ADDENDUM NO. 1

City of Spring Valley, MN
Wastewater Treatment Facility Improvements
Bid Date: October 27, 2026
Bid Time: 2:00 PM
BMI Project No. 0M2.131536

1 ELECTRICAL PLAN - AERATION BASIN

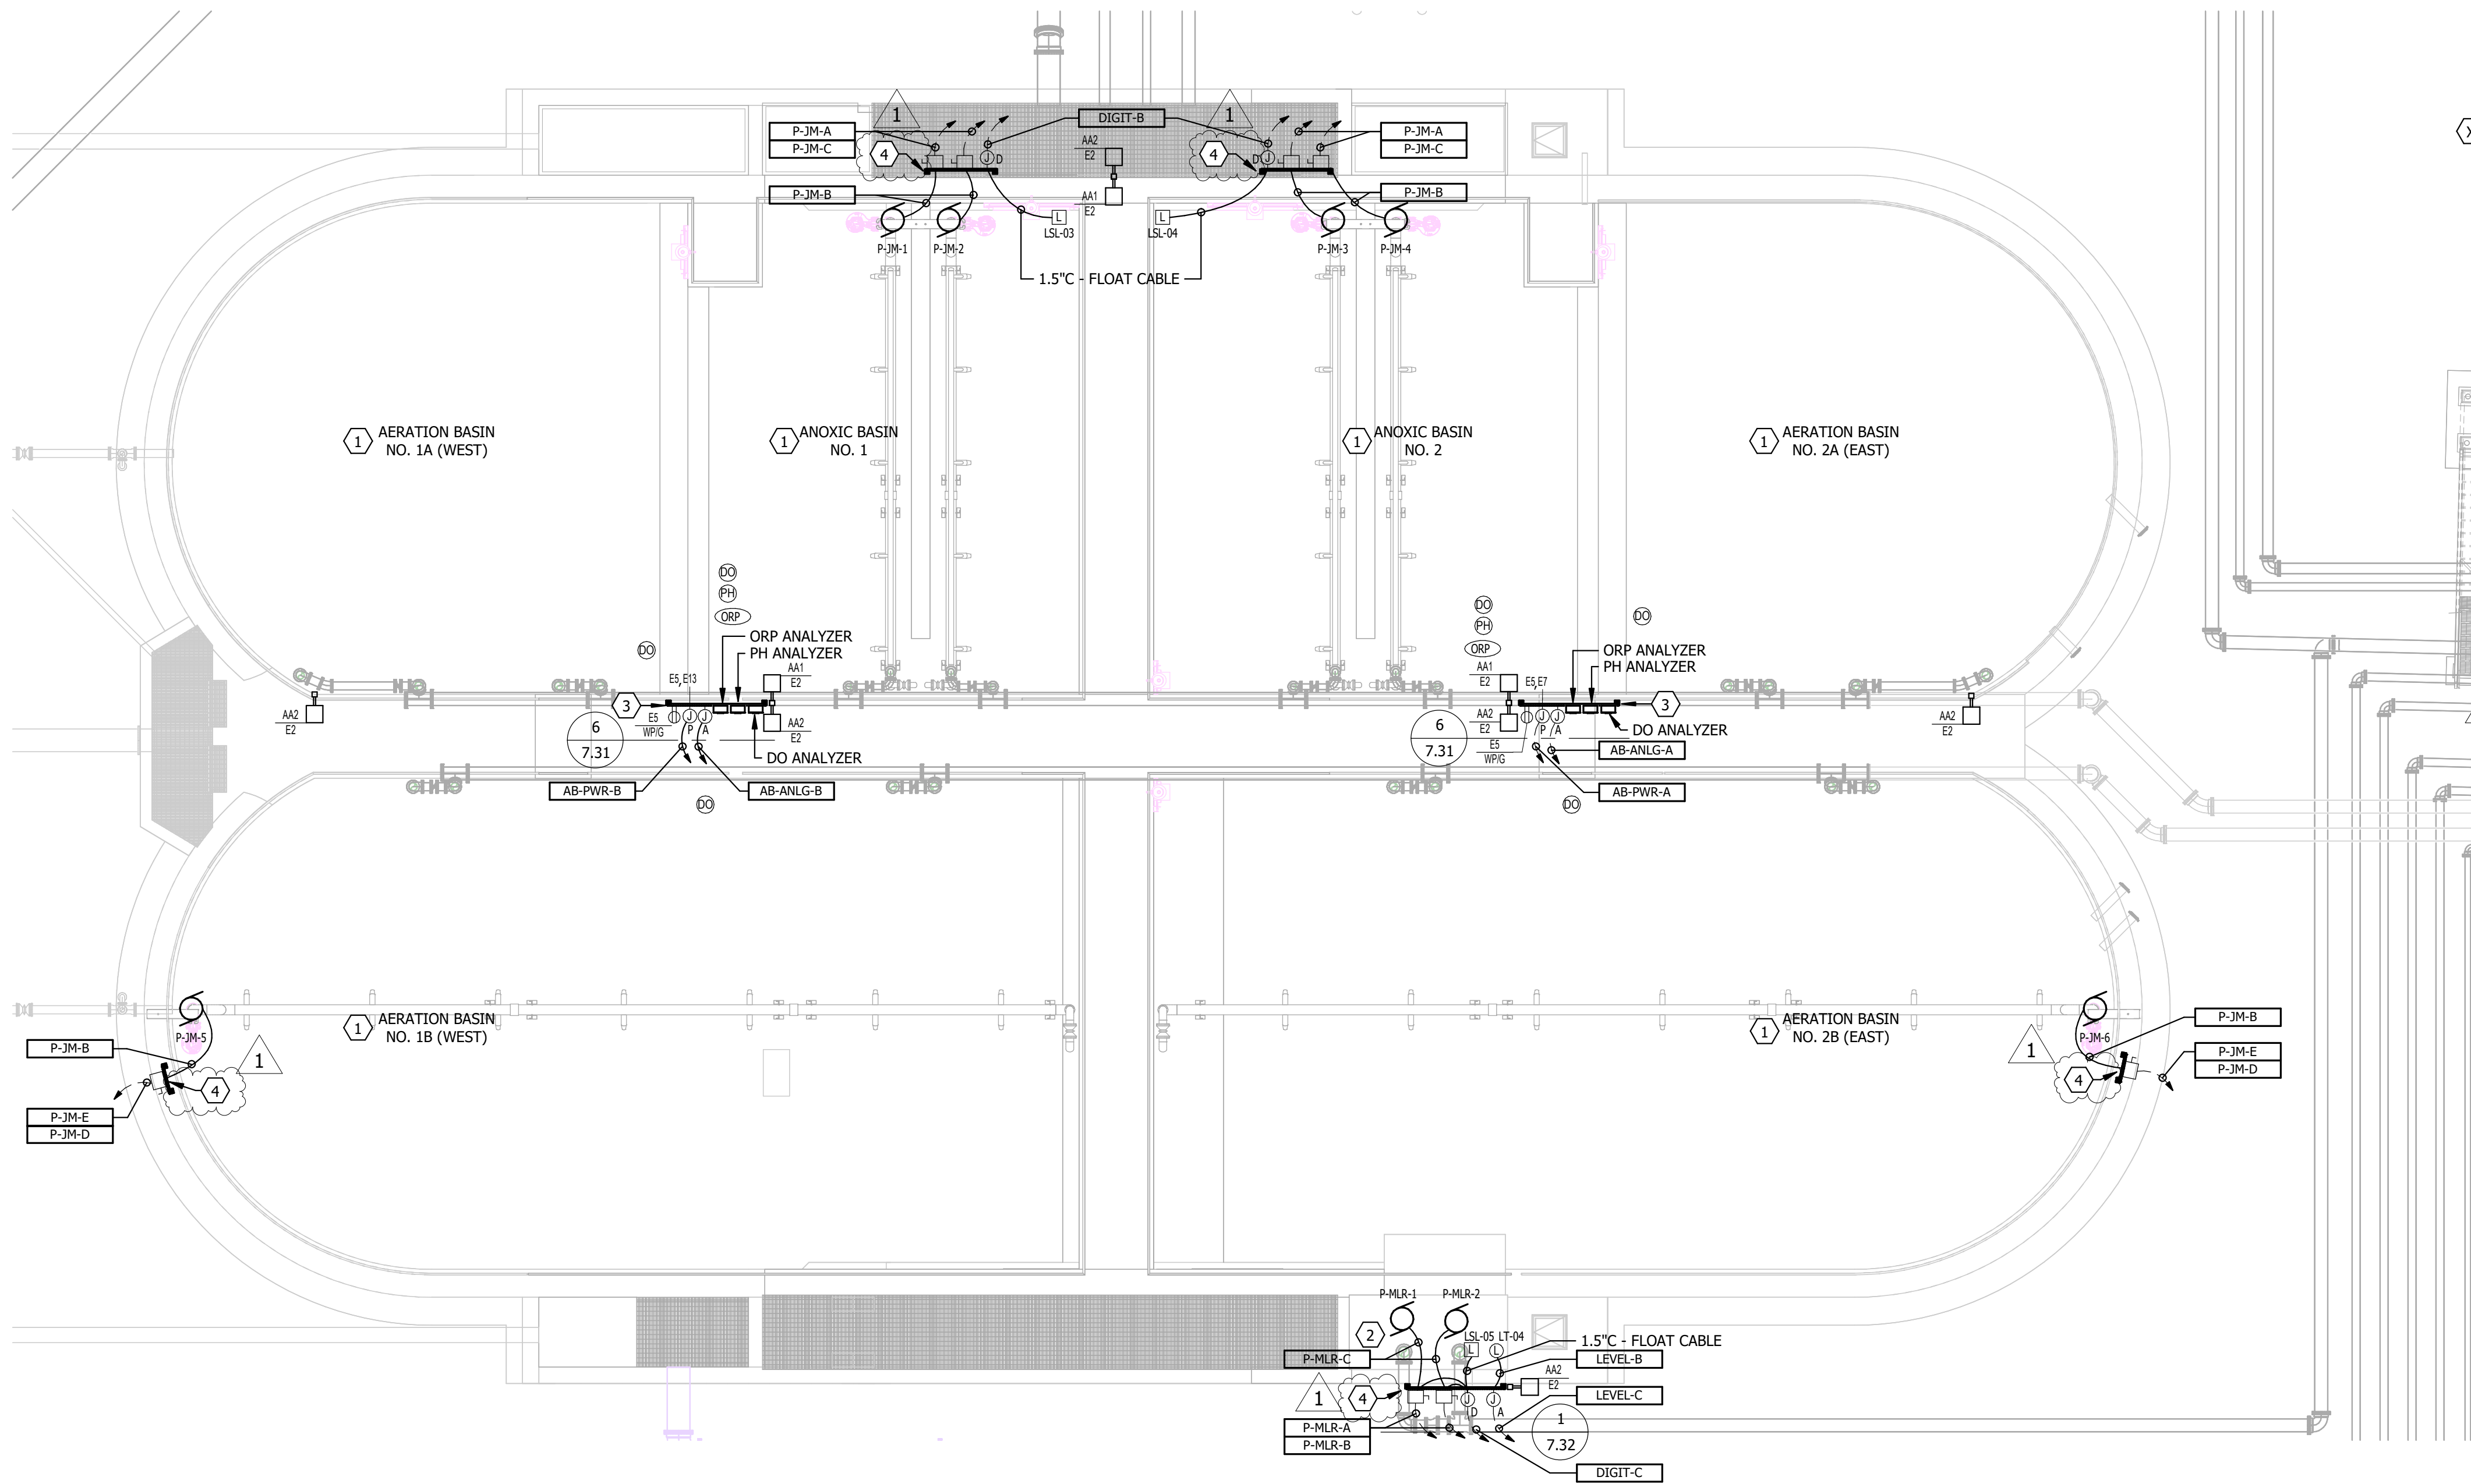
- Item II.1.11 Sheet 7.15 – Electrical Plan – Aeration Basin & Secondary Clarifier**
- a. Replace Sheet 7.15 Rev 0 09/29/2026 with attached Sheet 7.15 Rev 1 10/08/2026.

- b. Add keynote #4.
 - c. Place keynote #4 on floor plan, at called out Unistrut locations.
- Item II.1.12 Sheet 7.17 – Electrical Plan – Disinfection Building**

2 POWER & SYSTEMS PLAN DISINFECTION BUILDING

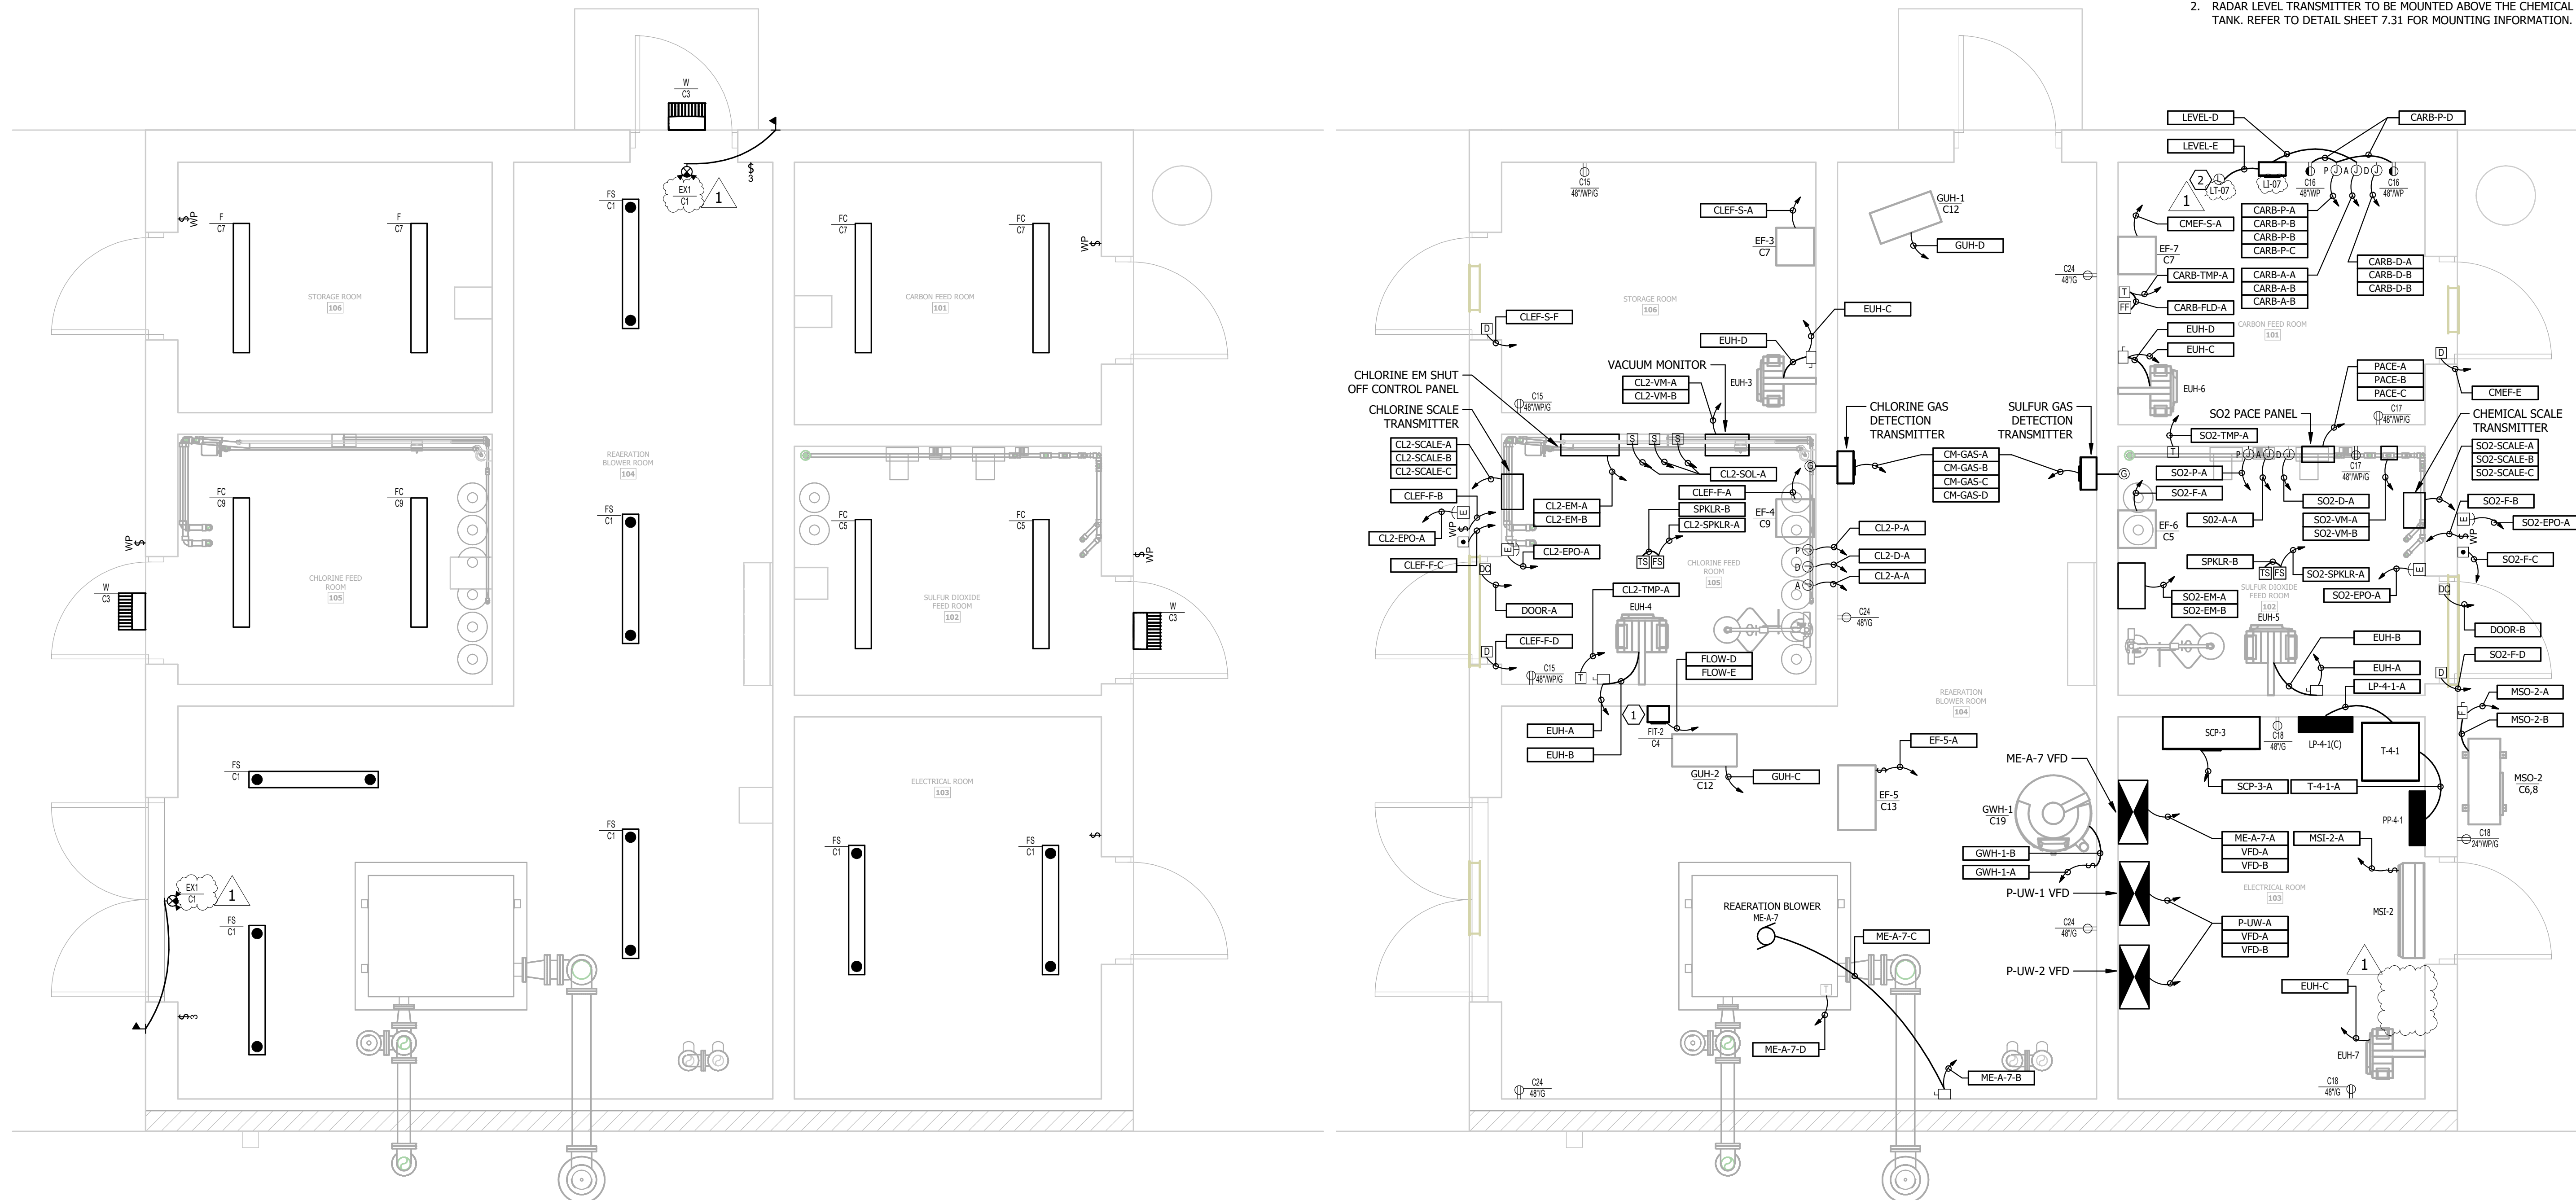
- a. Replace Sheet 7.17 Rev 0 09/29/2026 with attached Sheet 7.17 Rev 1 10/08/2026.
 - b. Rename transducer tag and transmitter to XX-07.
 - c. Electrical Room 103 – Remove disconnect for the EUH-7, revise the wire tags.

- d. Revise (2) Exit signs to EX1 type.
- Item II.1.13 Sheet 7.19 – Lighting Plan – Blower Building Upper Level**
- a. Replace Sheet 7.19 Rev 0 09/29/2026 with attached Sheet 7.19 Rev 1 10/08/2026.

1 LIGHTING PLAN BLOWER BUILDING UPPER LEVEL

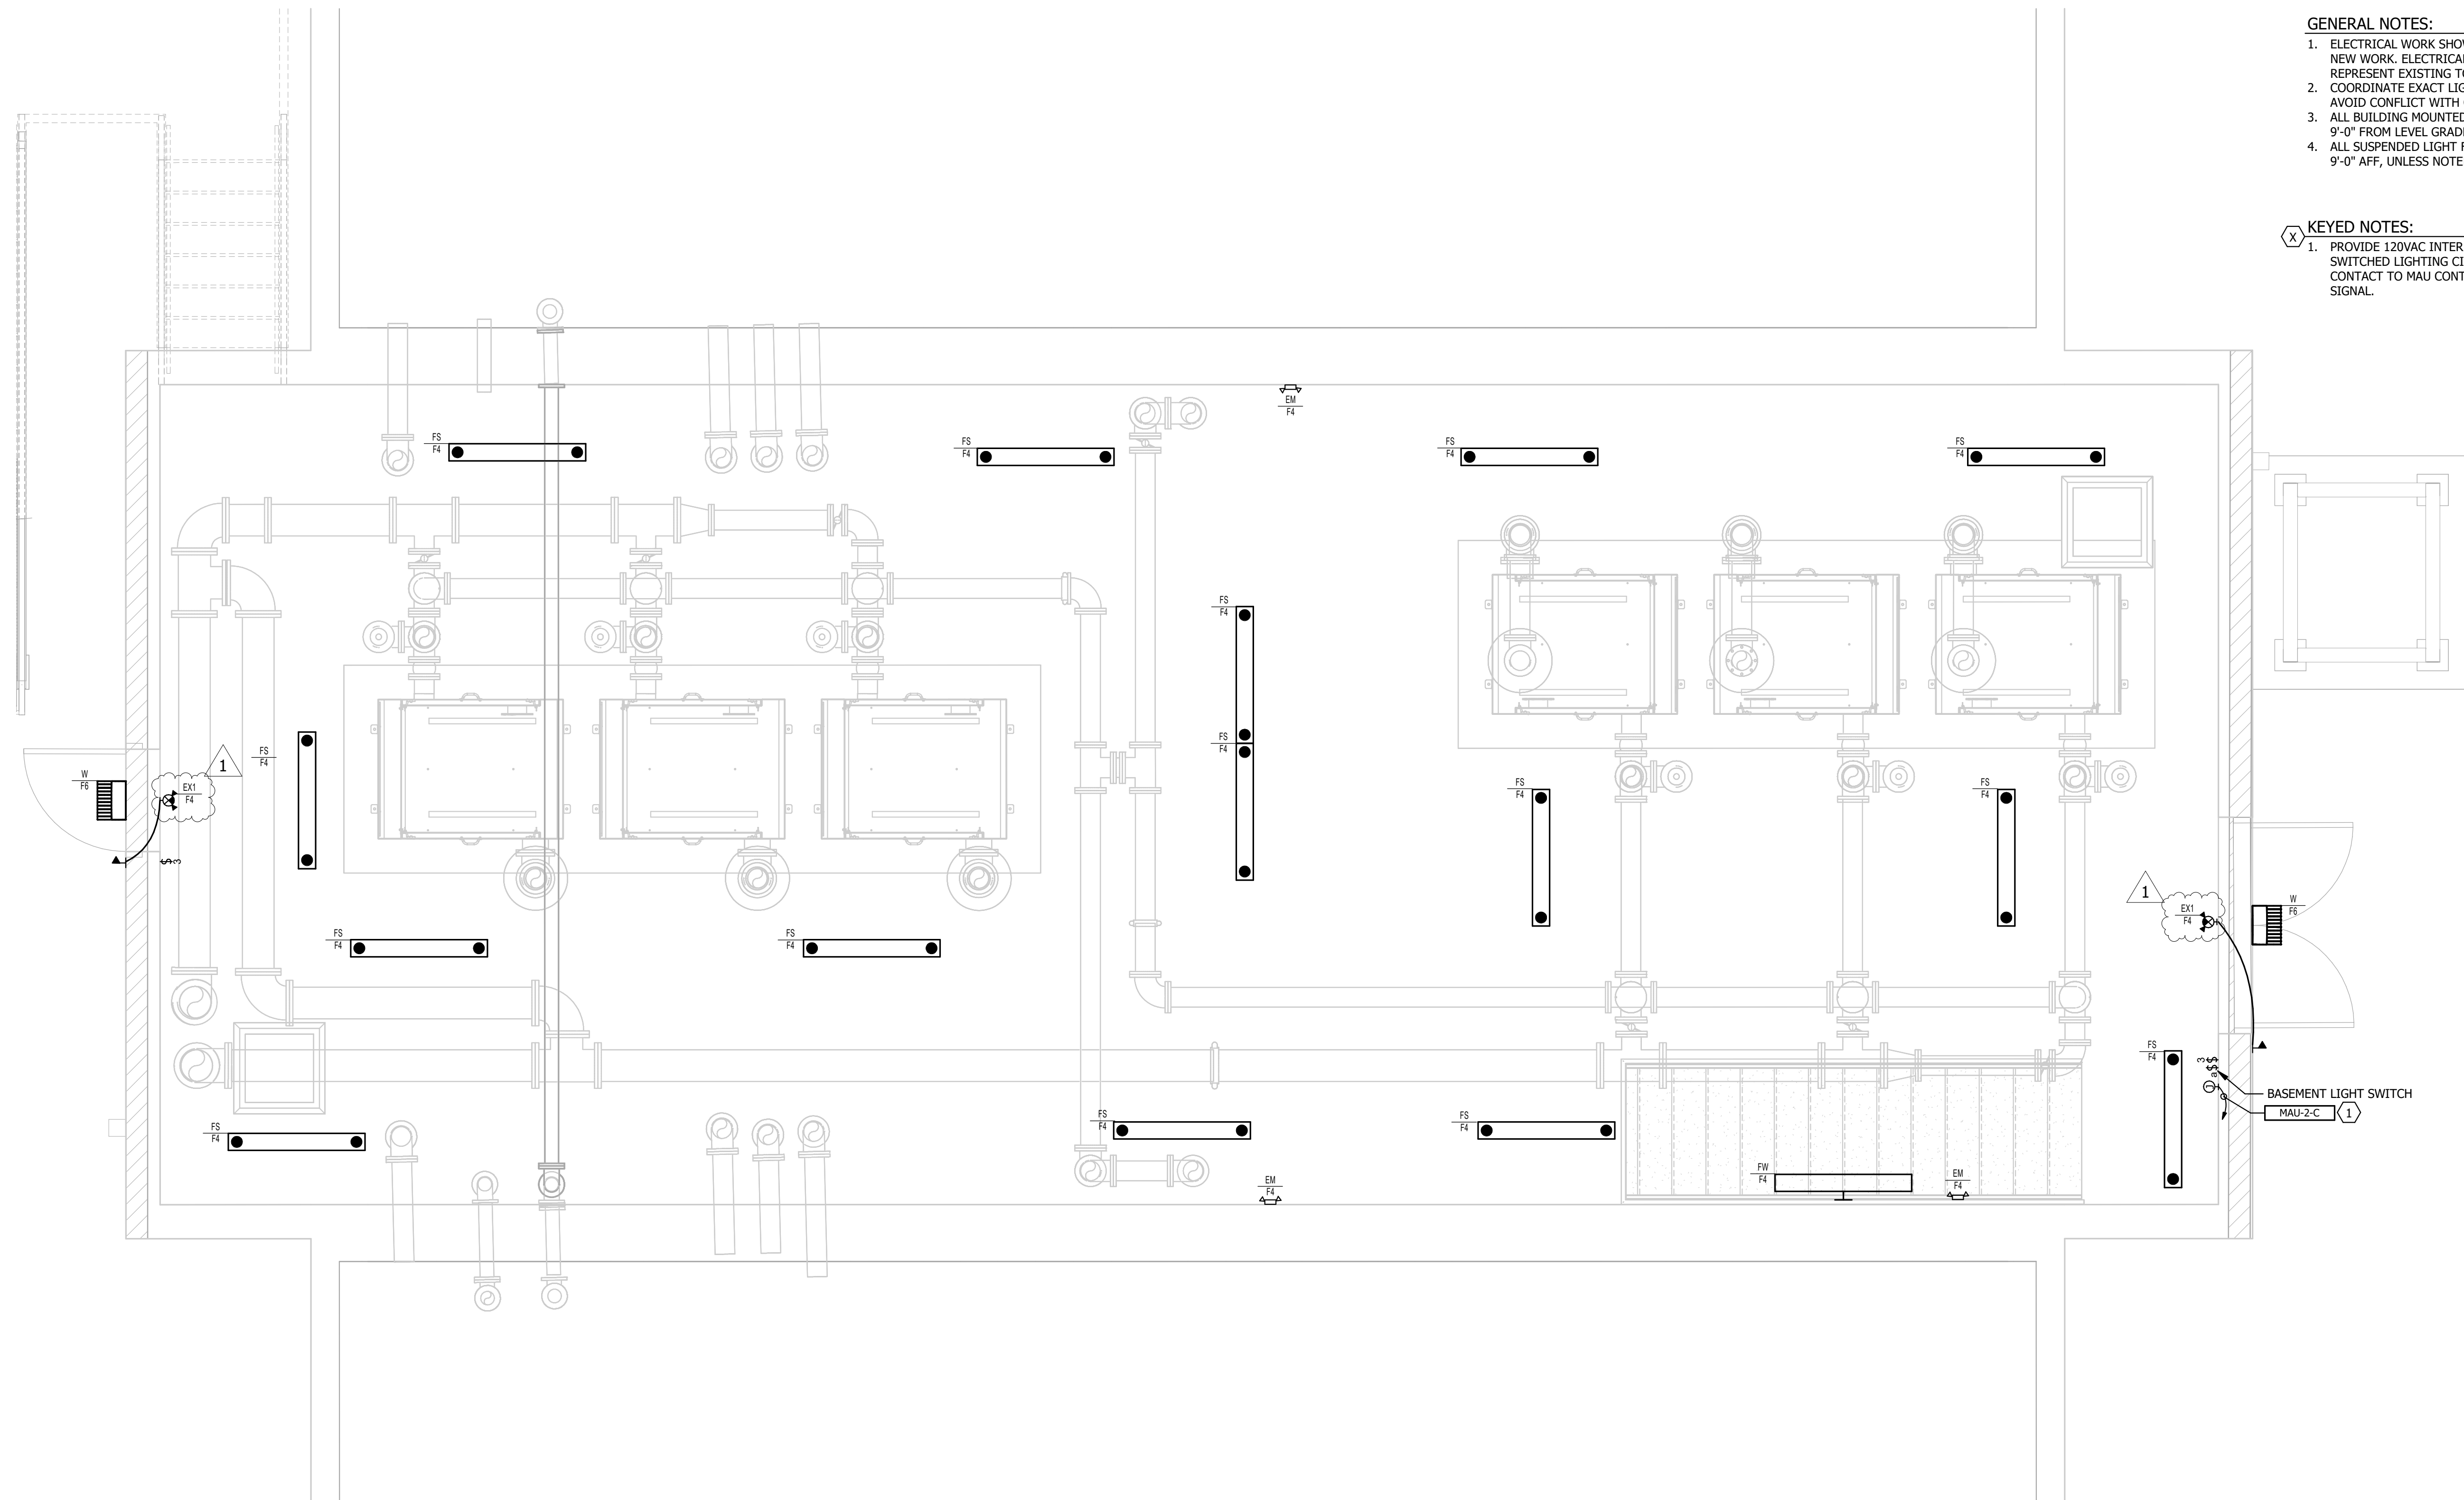
- b. Revise (2) Exit signs to EX1 type.
- Item II.1.14 Sheet 7.21 – Power & Systems Plan – Blower Building Upper Level**
- a. Replace Sheet 7.21 Rev 0 09/29/2026 with attached Sheet 7.21 Rev 1 10/08/2026.
